RECTIFIER TRANSFORMER

EMCO TRANSFORMERS LTD.

REV. 3. 16/12/97	REV 2 : 31/08/97	W.O.	UT098/B
AS BUILT	TYPE OF COOLING CHANGE TO ONAN FROM OFWF	DRN PRD	VLK
		CHD APPD	VSP
DATE	23/09/96	SCALE - NTS	
		MAIL -	
RATING PLATE 20 KA, 100V SYSTEM 1 1		EMCO TRANSFORMERS LTD. MUMBAI	
DRG. No. 2/11/0075/R3

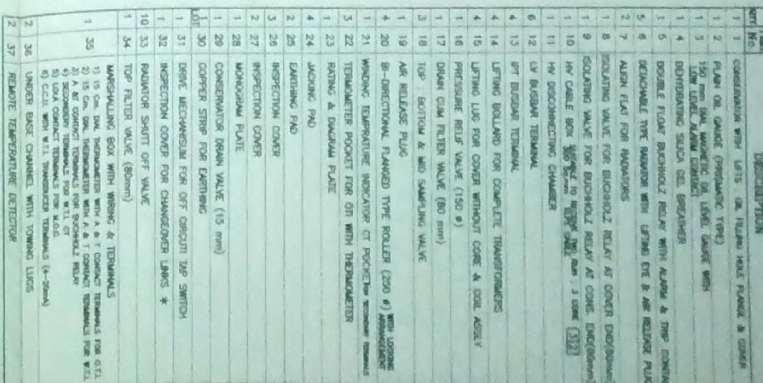
Revision Details		
Rev No	Sl No	EL's Comments
1	1	Description in the title block changed to "Rating Plate 20KA, 100V System" from "Rating plate".
1	2	Switch connection details for tap positions 2-16 revised
1	3	ABB's Comments: Interphase transformer current changed to 2x10KA from 2x20KA
2	1	Type of cooling changed to ONAN from OFWF
2	2	Rating of primary KVA changed to 2644 from 2654.2
		Other clarification sought by EL on revision "Q" are given in ABB's letter No. IAD2WB6104-006 dt. 970527
3	1	Rating of primary KVA changed to 2654.2 from 2644
